# Section 75W Modification Environmental Assessment Report

## One Central Park

Modifications to Approved Mixed Use  
Residential, Commercial and Retail Building and associated  
Public Domain (MP09\_0078)

December 2010 ■ 10566

Figure 2 – Comparison of approved (orange) and proposed (yellow) building envelopes

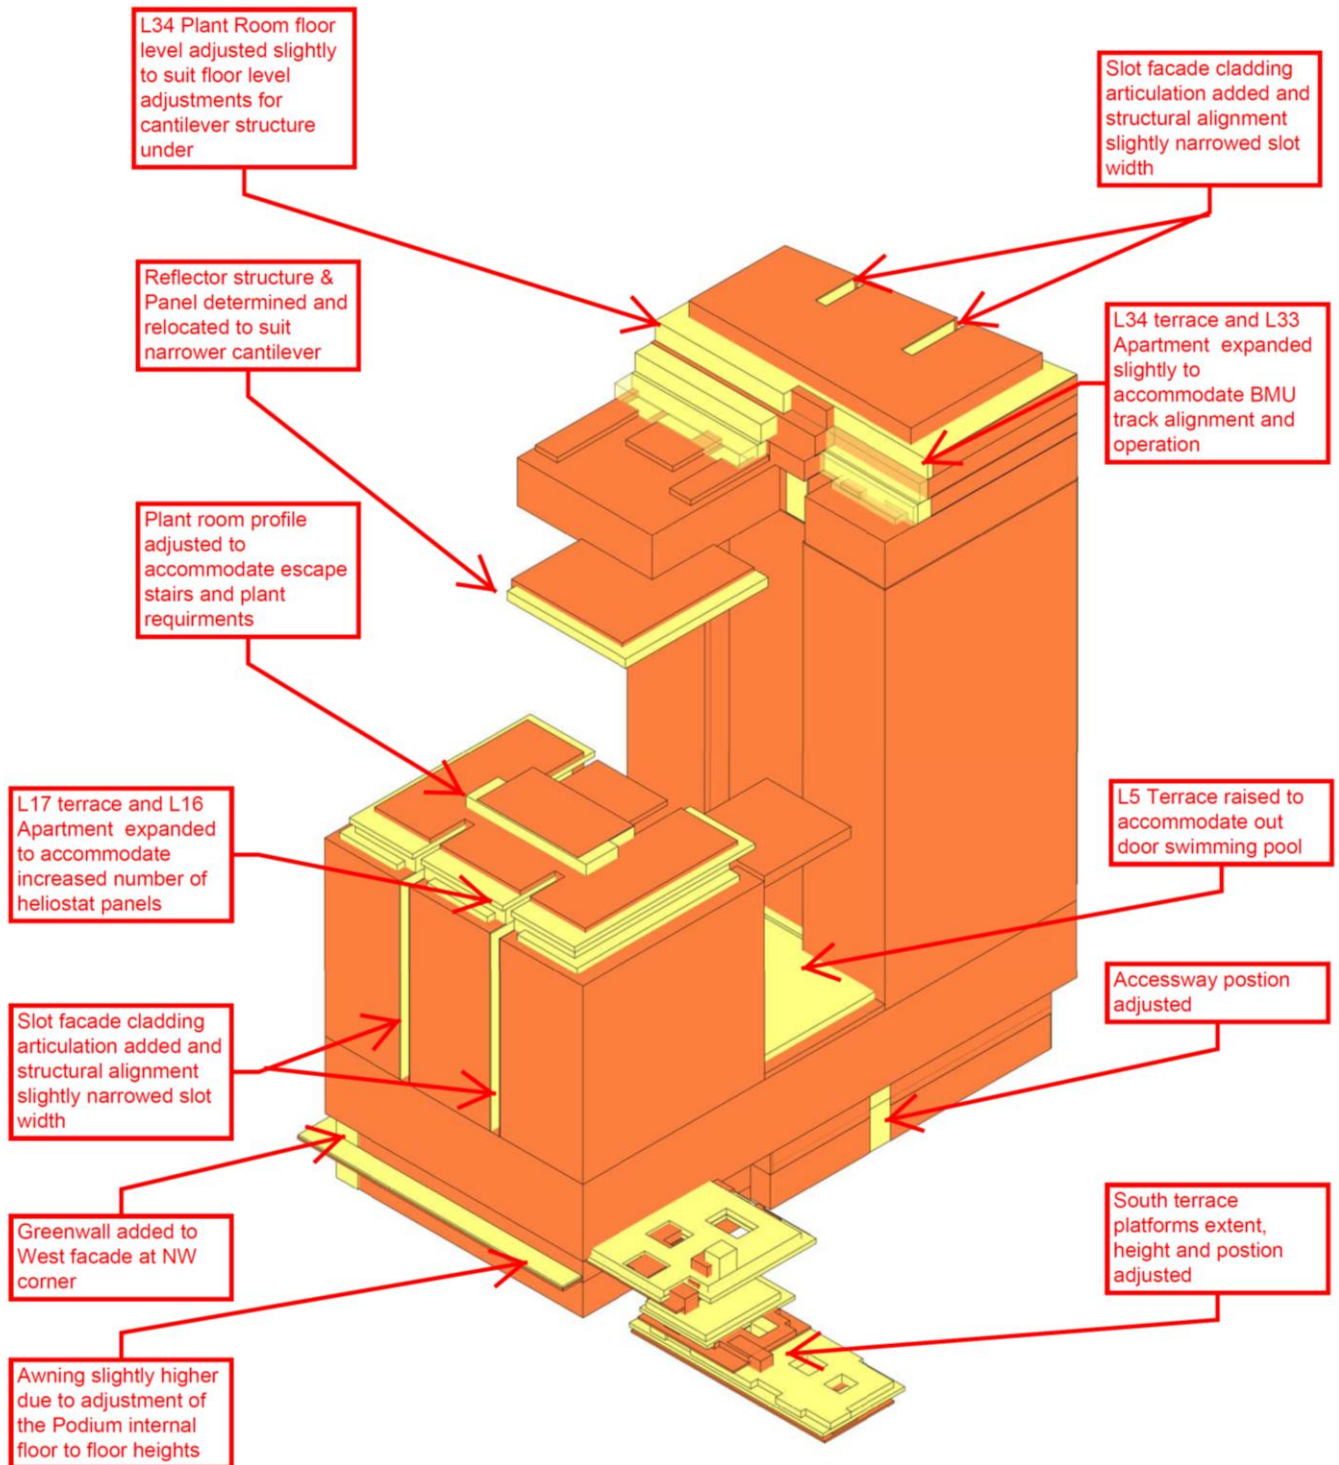
**Figure 2** provides a comparison of the approved building envelope and the proposed building envelope whilst **Figures 3** and **4** provides a comparison of the proposed building envelope and the approved Concept Plan envelope. The details of what the amendments relate to are also provided in the image.

Figure 6 – Revised ground floor plan

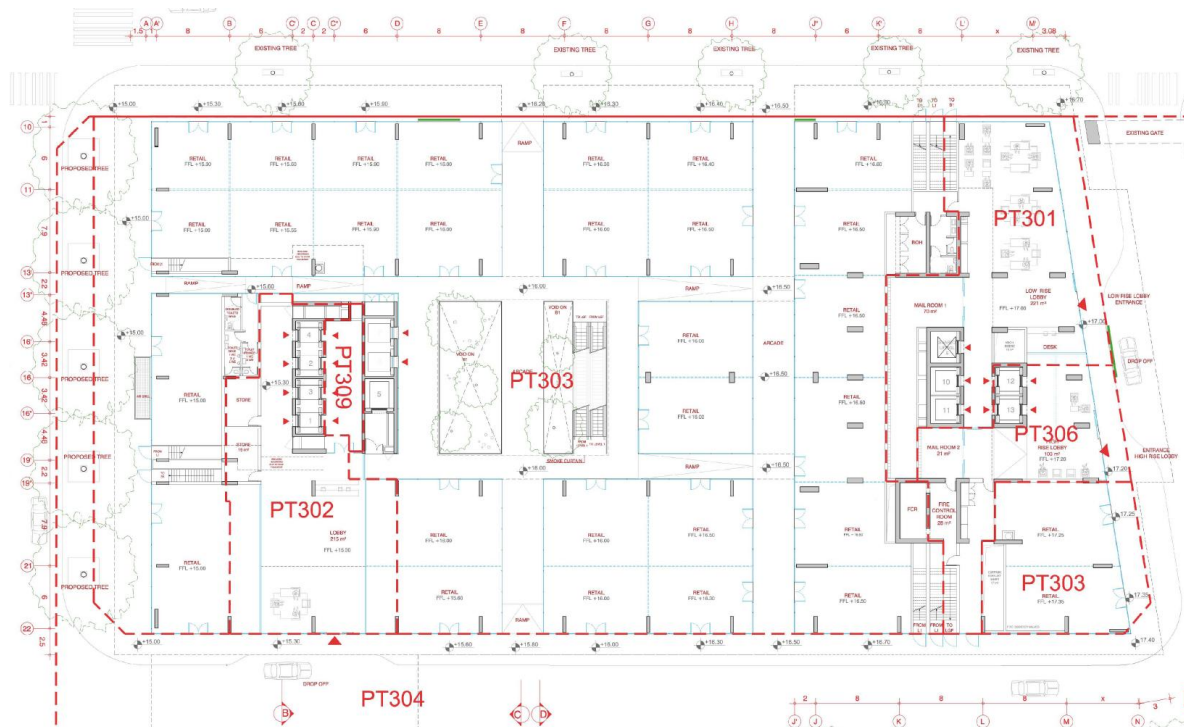
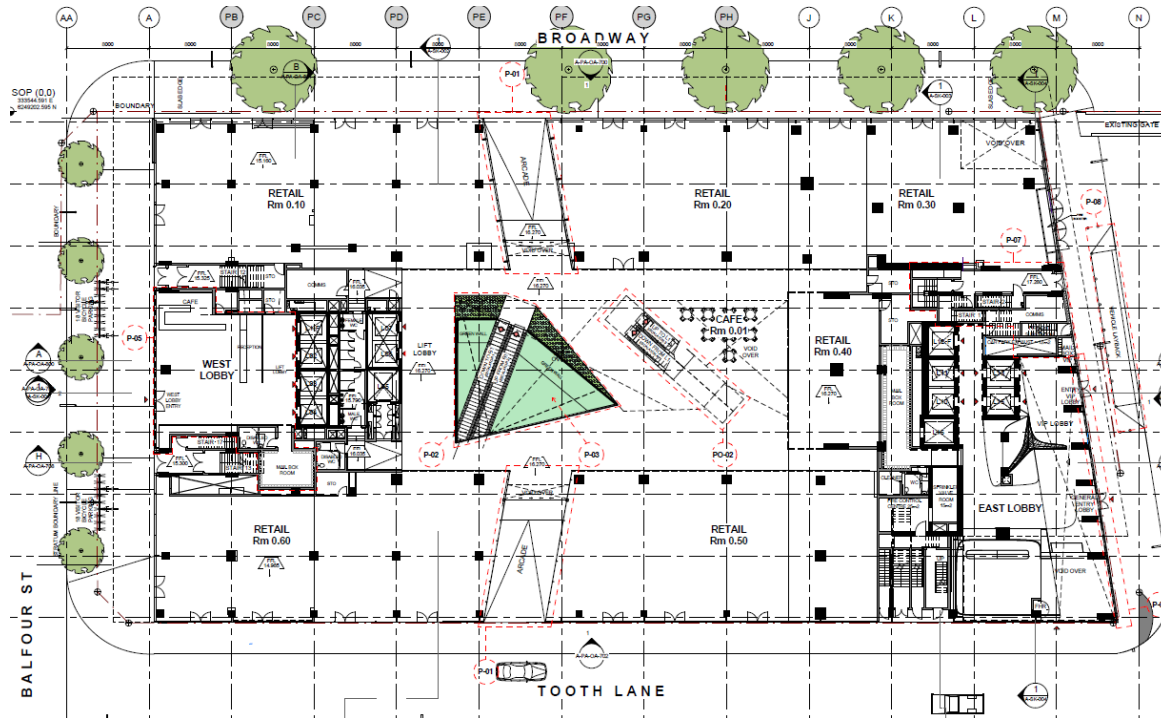
- Ground Level (existing shown in **Figure 5** and proposed shown in **Figure 6**)
  - Central atrium reconfigured and increased in size
  - Two 4.5m through site links reduced down to one 6m through site link
  - Eastern residential lobby reduced in size
  - Western lobby relocated to Balfour Street
  - Retail reconfigured

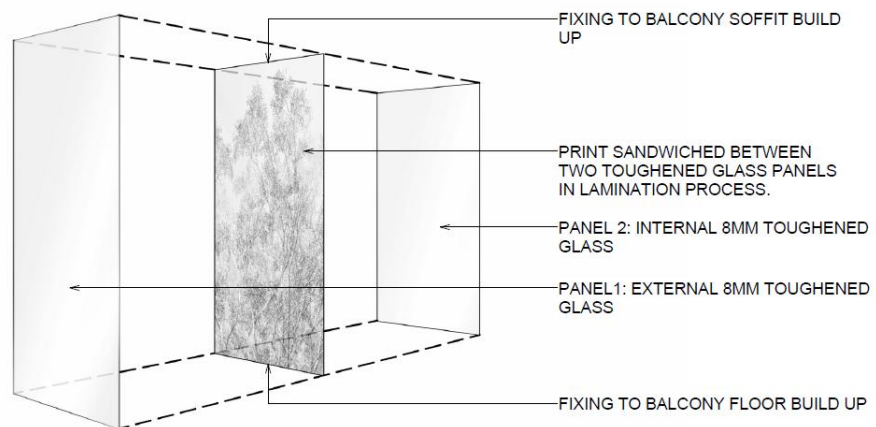
The design of the Green Walls has been reviewed from an operational perspective which has resulted in the following changes:

- The area of the green panels has been increased by 20% from 1,136m<sup>2</sup> to 1,378m<sup>2</sup> with 24 panels proposed in total.
- The depth of some of the planters has reduced from 2m to 1m.
- The linear length of the planter boxes has increased from 1700m to 2400m (40%).
- West elevation planters and façade line has been adjusted to match the north and east.

Figure 10 – Section of the platforms over Tooth Lane

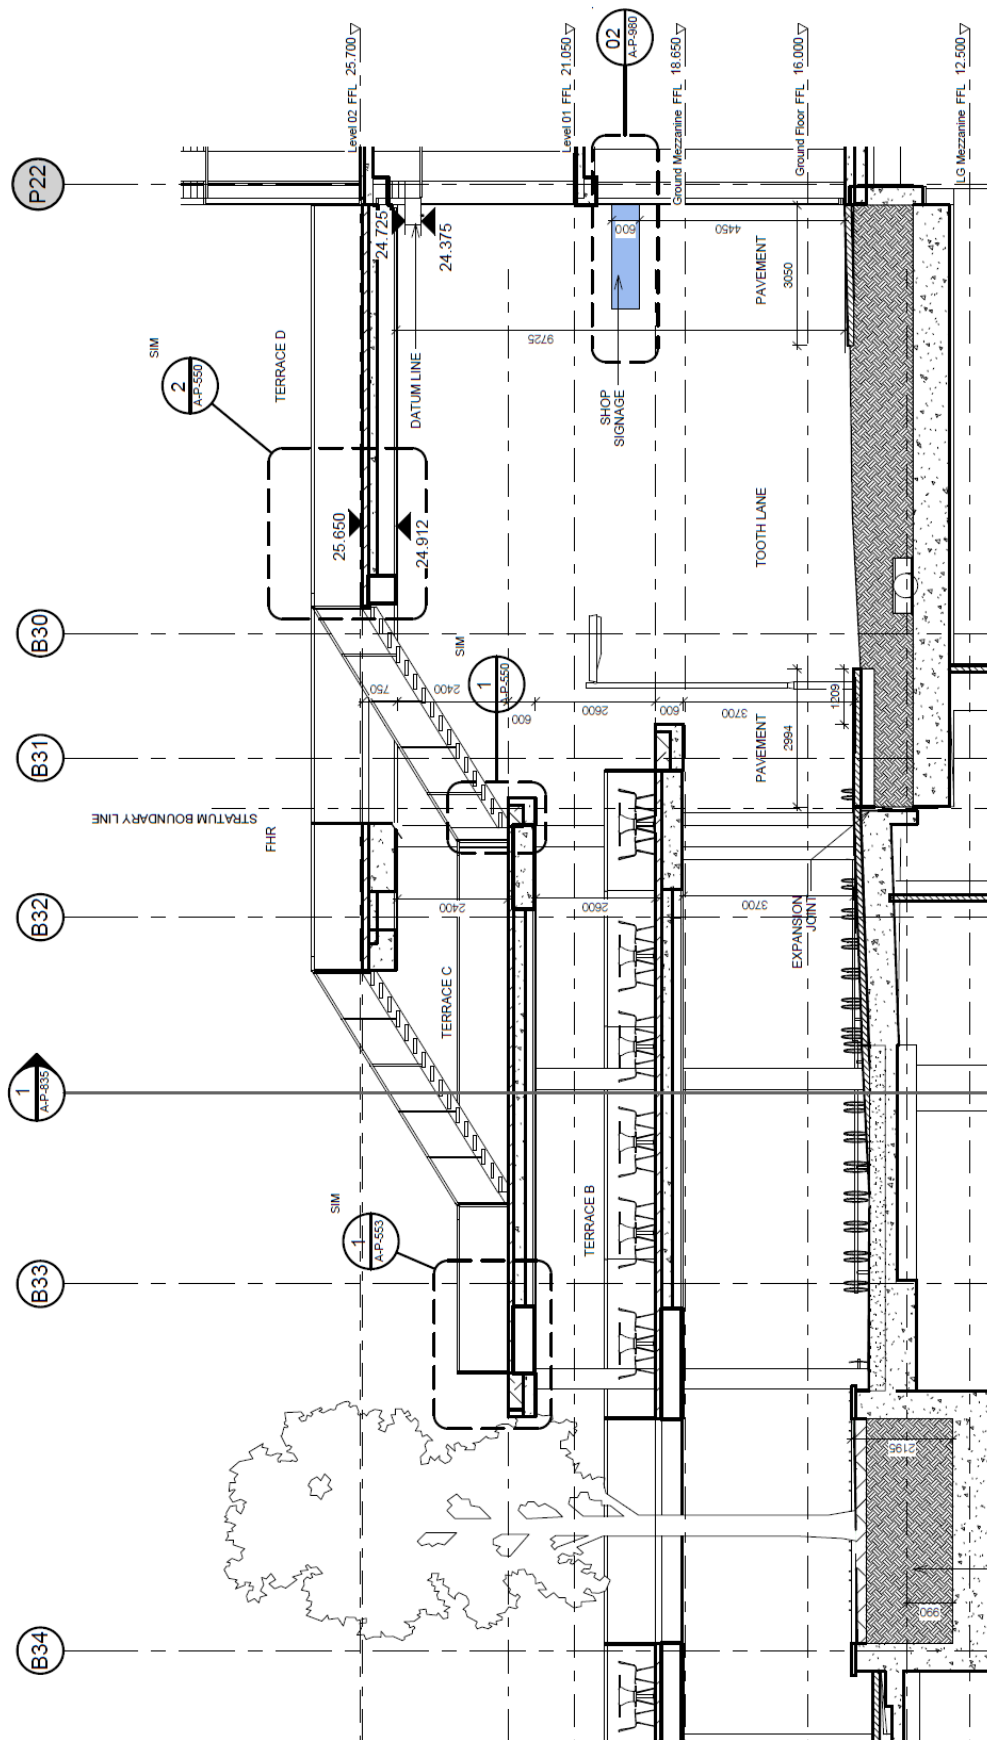
In order to provide sufficient fire egress from the food court level of the podium, it has been necessary to revise the design of the stair system on the platforms. Two sets of 3m wide stairs are now provided within the platforms to comply with the requirements of the BCA. The height of the platforms has increased by 250mm and Tooth Ave has been graded lower at the Balfour St end to increase the clear height under the platform over by approximately 800mm.

An indicative image and section of the platforms is provided in **Figures 9** and **10** respectively.

**Figure 11** – Revised Heliostat design

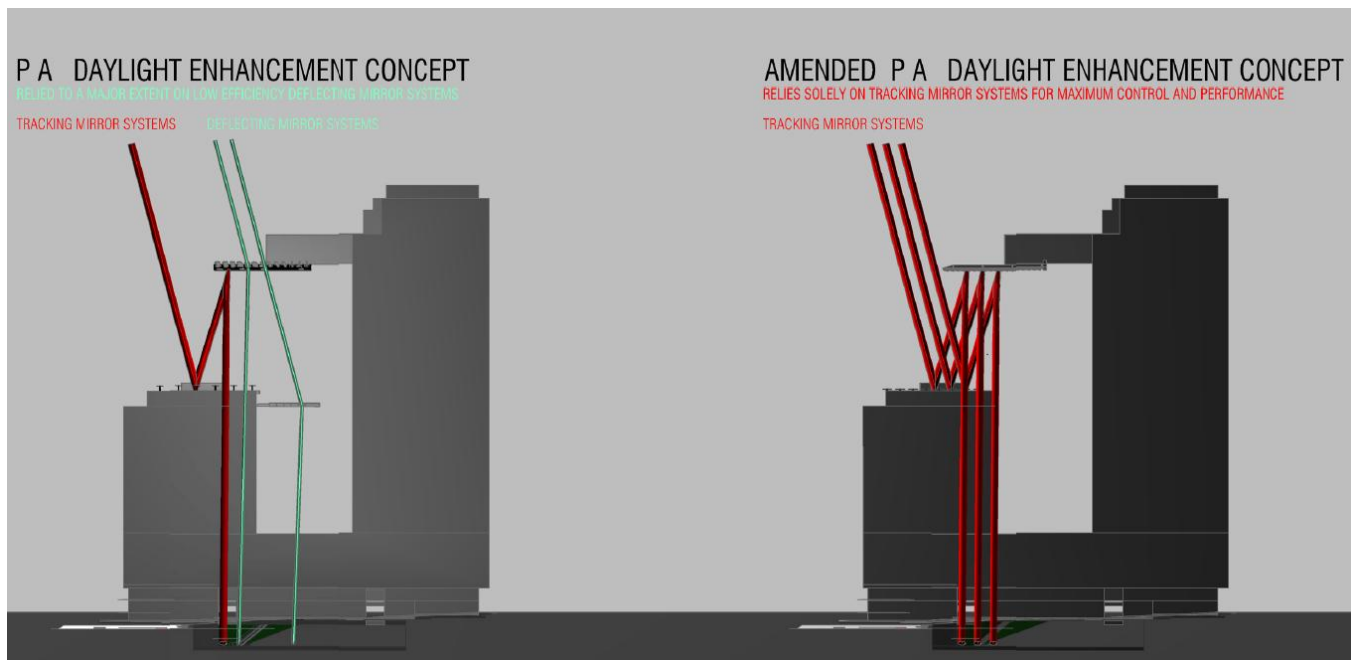
The design of the heliostat has been significantly developed and improved. The total number of fixed mirrors cantilevered from the east tower has increased from 97 (388m<sup>2</sup>) to 324 (506m<sup>2</sup>) and the number of sun tracking heliostat mirrors on the western tower has increased from 12 (48m<sup>2</sup>) to 48 (300m<sup>2</sup>).

In order to accommodate the additional mirrors, the size of the heliostat has increased from 22m x 26.2m in the PA to 23m x 26.95m. However, the cantilevered heliostat on the western tower has been deleted and replaced by additional mirrors on the roof of the building where they are not visible from any public space.

Figure 13 – Proposed publicly accessible link

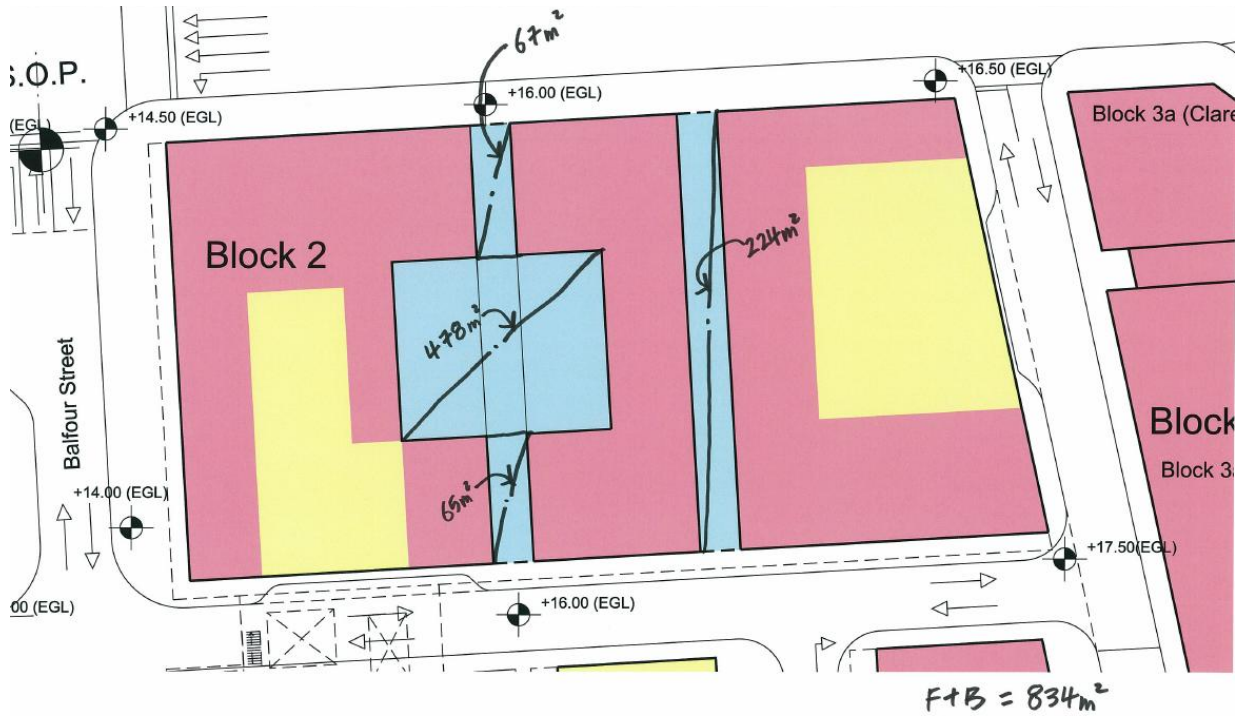
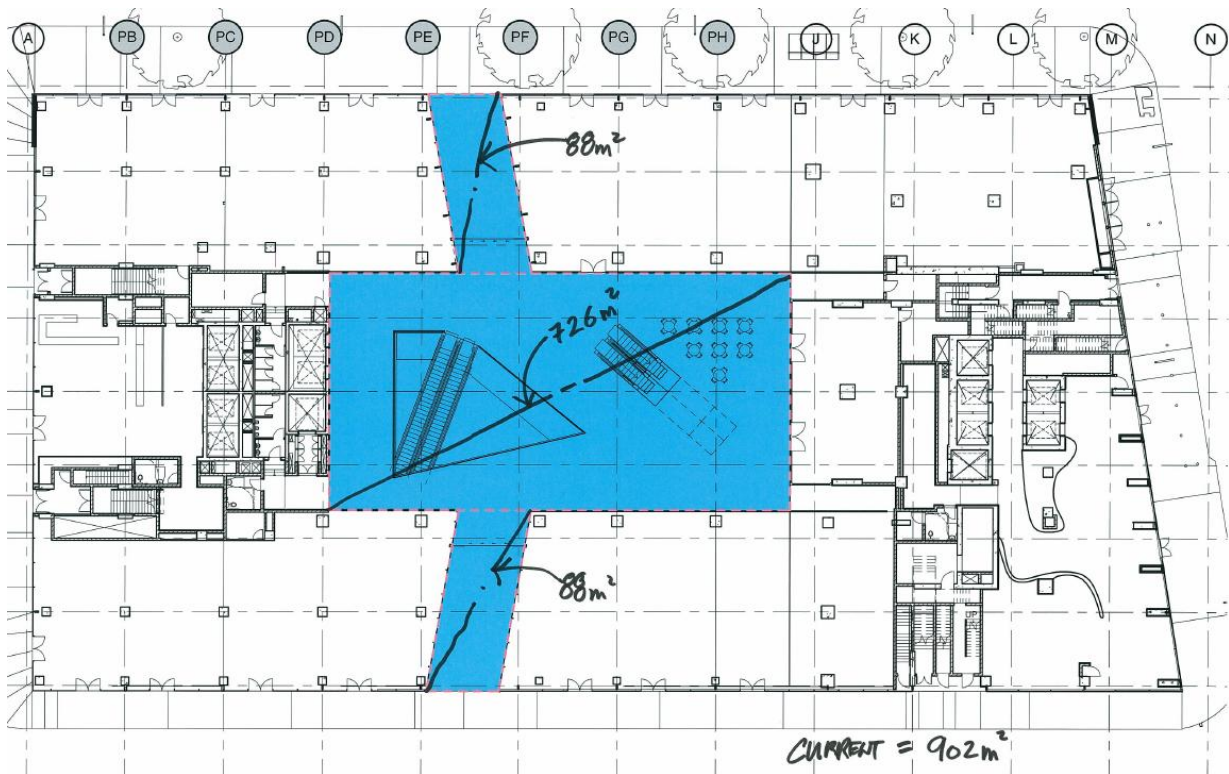
With regard to the publicly accessible through site links at ground level it is noted that the links will be reduced down from two links to one link, however the width of the links will be increased to 6m. The proposed amendment is considered to be an improvement on the approved design for the following reasons:

- The publicly accessible space is increased from 834m<sup>2</sup> up to 902m<sup>2</sup> (8.5% increase) (See **Figures 12 and 13**);
- The internal atrium space is significantly larger (478m<sup>2</sup> up to 726m<sup>2</sup>), thereby providing a space which has a higher level of amenity; and
- The proposal retains a through site link from Broadway to the Main Park.
